From: Ron Wolanski, Town Planner

Date: October 1, 2024

Re: **Public Hearing** - Application of 72 Johnny Cake Hill, LLC for Development Plan Review for modification to a previously approved plan for construction of a 15,000 sq. ft. wholesale commercial use building, with associated parking, office space, landscaping, stormwater management, utilities, and associated site work, and including requests for waivers from certain design requirements of Section 521 of the Middletown Rules and Regulations Regarding the Subdivision and Development of Land. Property located on 72 Johnnycake Hill Road, Assessor's Plat 114, Lot 601.

1 NORTH ELEVATION PROPOSED
1/8" = 1'-0"

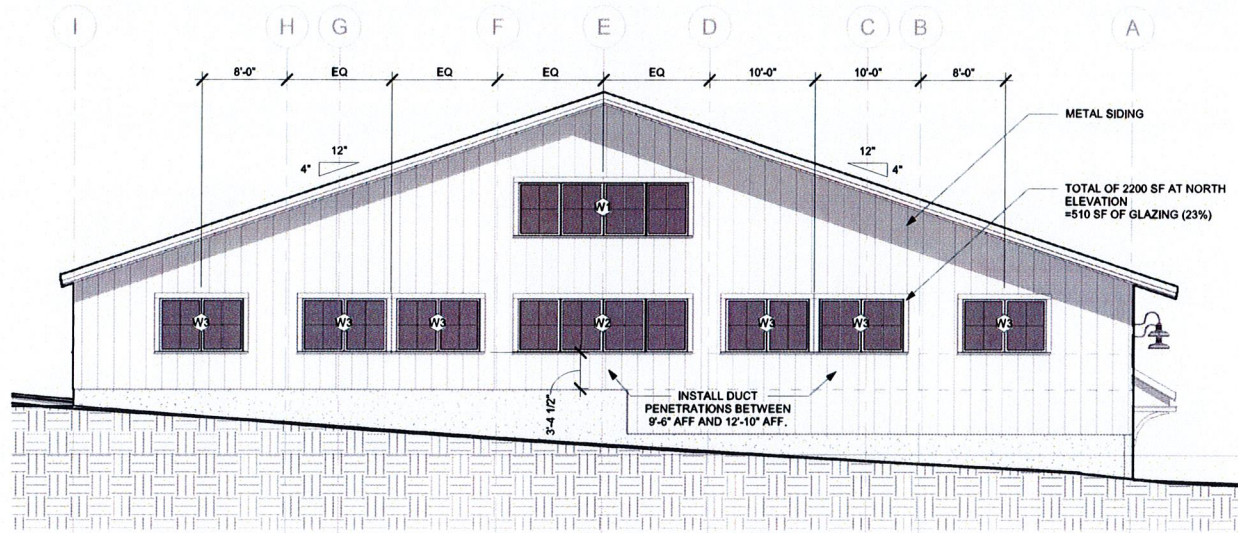
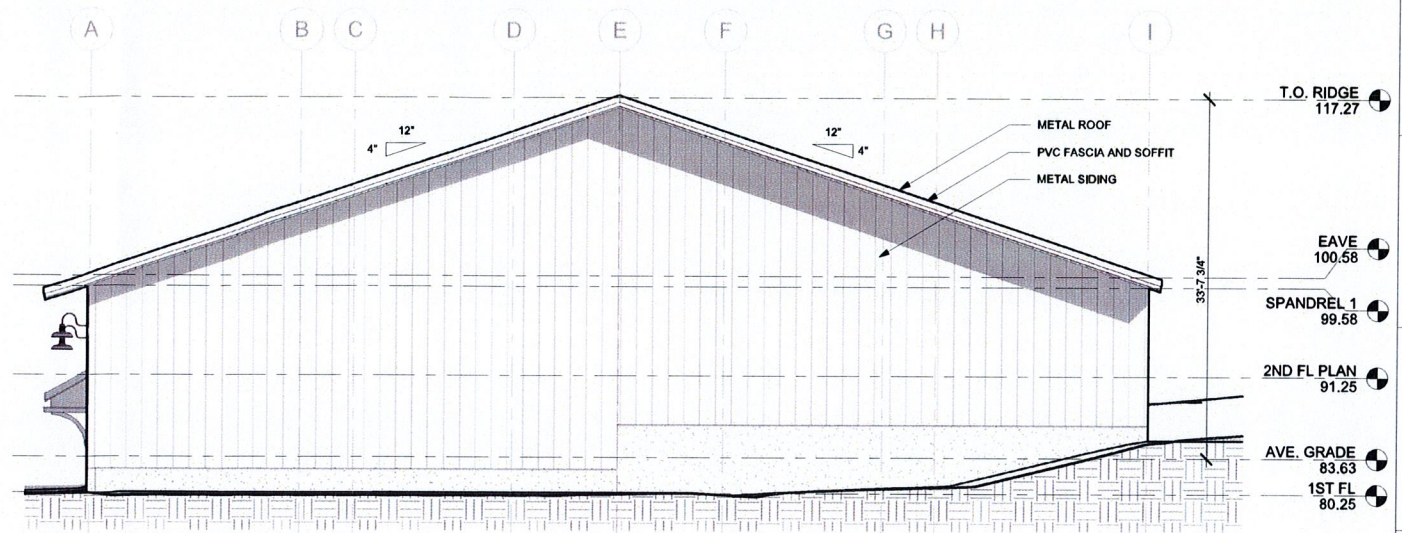
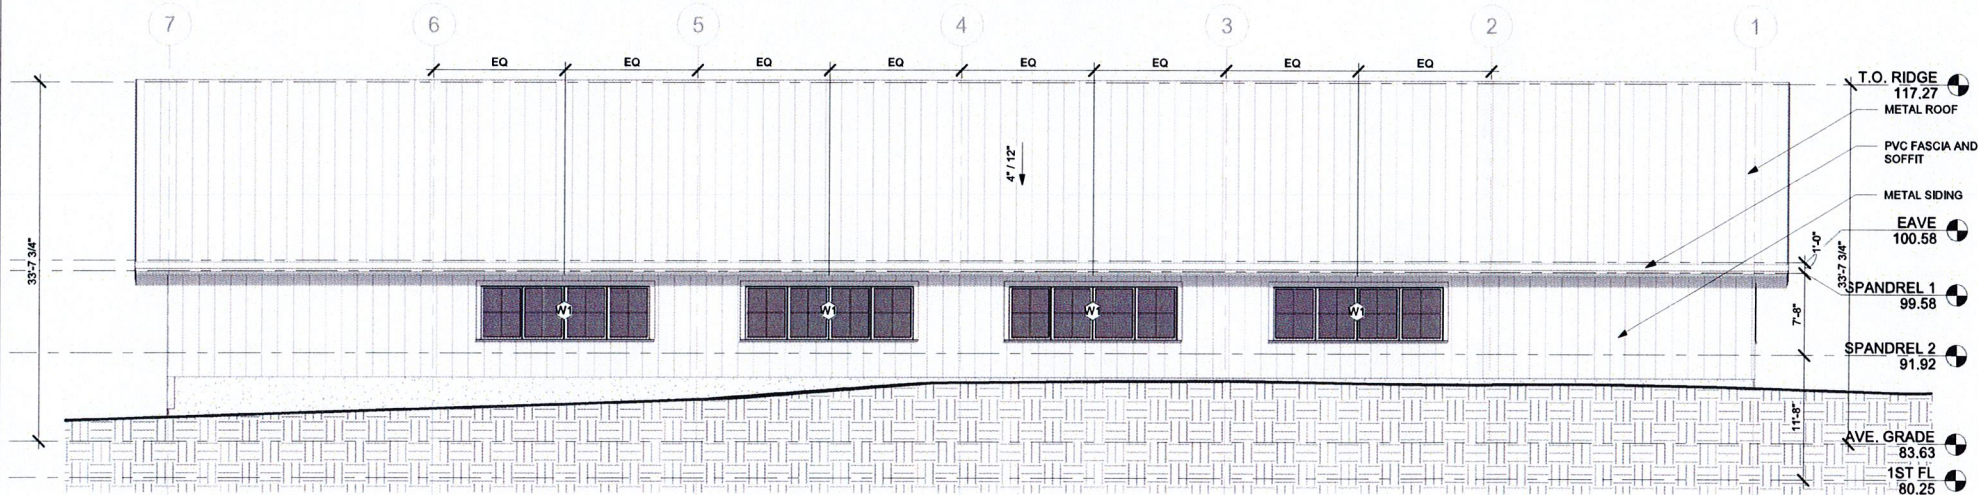
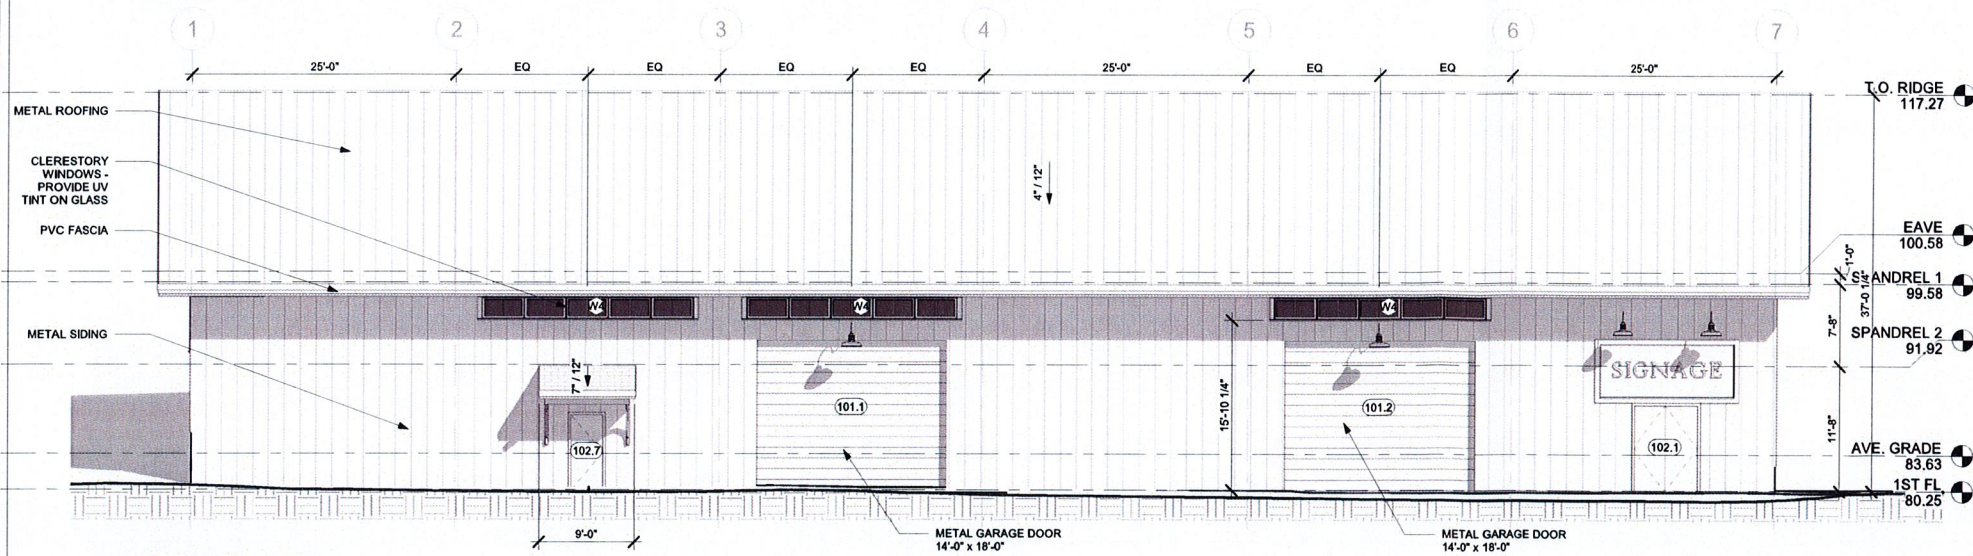
1. Section 521.2.A.2 – Street side façade does not consist of an unarticulated blank wall, does not consist of an unbroken series of garage doors, and no unbroken plane of a wall exceeds forty feet without a minimum 4 feet wide architectural design feature. Proposed street side façade consists of an unarticulated blank wall and walls exceed forty feet without a 4 feet wide design feature.

2. Section 521.2.B.1 – Windows and glass doors occupy between 20% and 60% of façade visible from the public way. No windows are proposed on the street-facing façade.

3. Section 521.2.C – Building sidings, roofs, and trim shall be constructed of traditional materials. Substitute materials may include fiber cement board, composite that resemble traditional materials, standing seam metal roofs, and non-flammable siding (Use of non-traditional or substitute materials require Planning Board or Administrative Officer approval). Building exteriors include a metal roof, metal siding, and PVC trim.

PLANTING PLAN

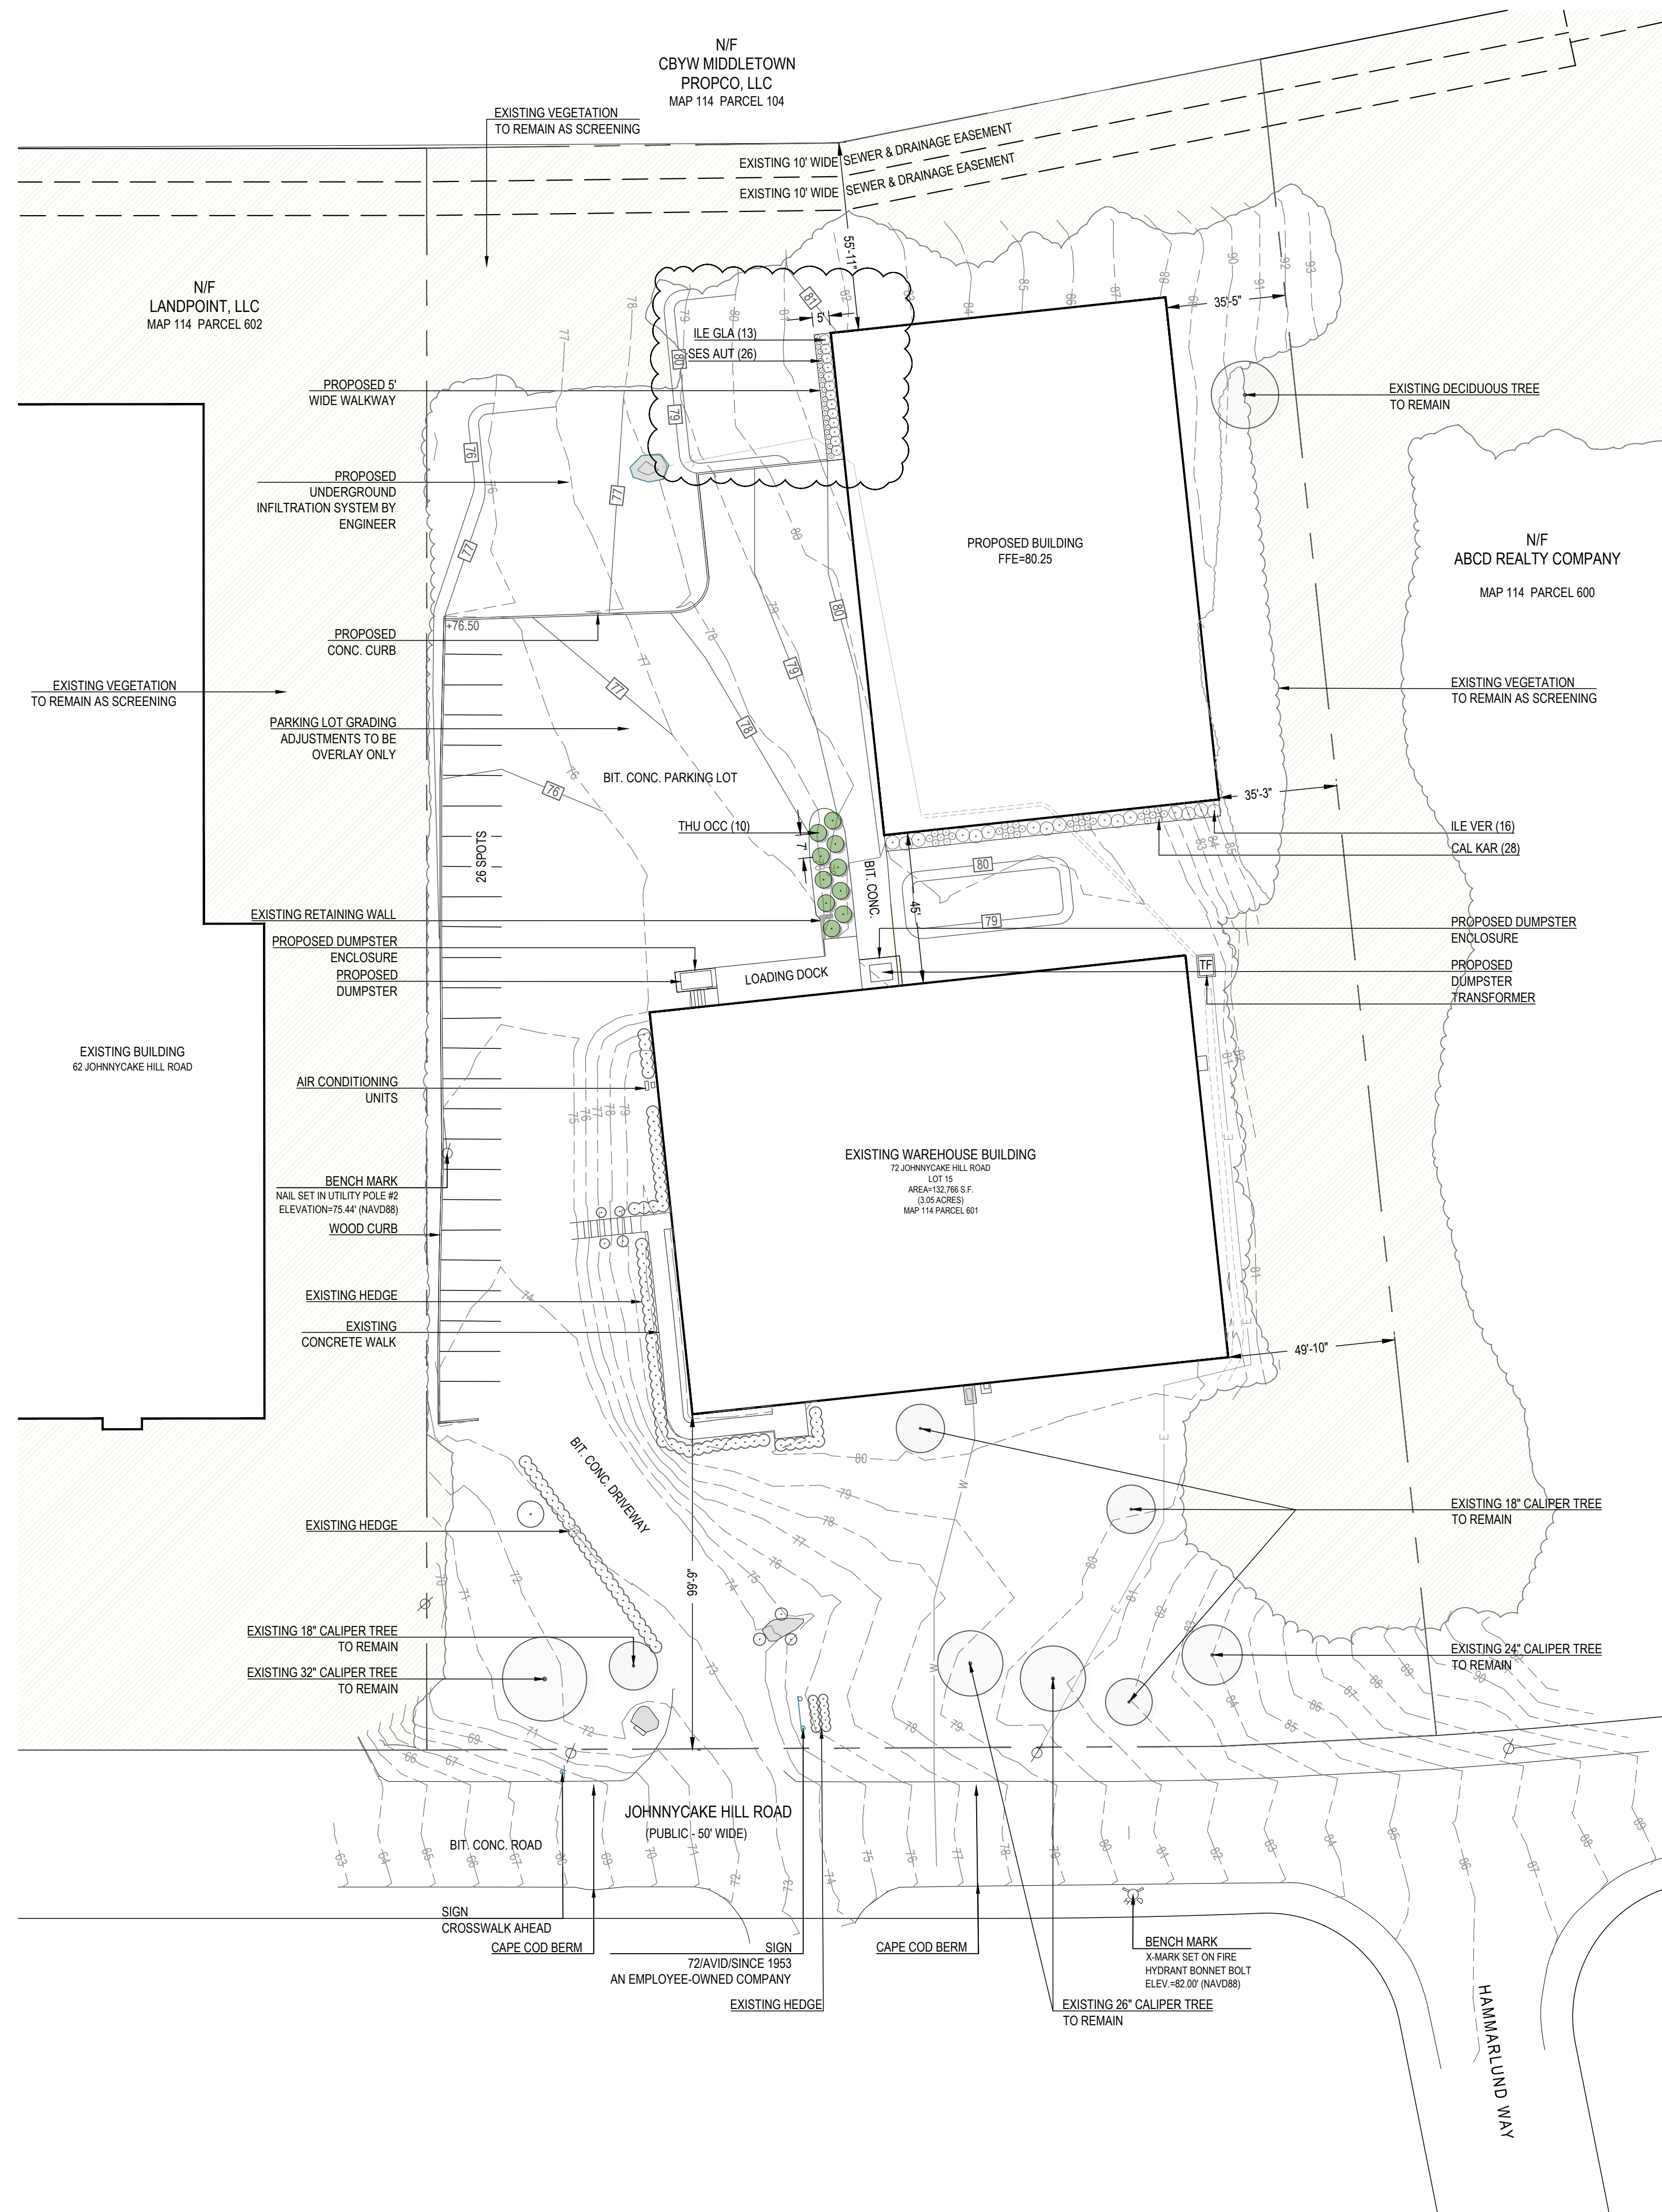
2. A plan for an additional building at 72 Jonnycake Hill Road was reviewed. As the existing vegetation is remaining and arborvitae plantings are to be added, we have no concerns except for the use of "Little bunny" fountain grass in a commercial setting. The landscapers on our Commission feel it is not long lived and may struggle and suggest perhaps sesleria autumnalis as a possible alternative.

An upright juniper like a chinensis or scopulorum variety would be more deer resistant than arborvitae.
The comment on the "Little Bunny" meant to replace it with Sesleria autumnalis.

01.29.2024	CHANGE GRASS TO SES AUT
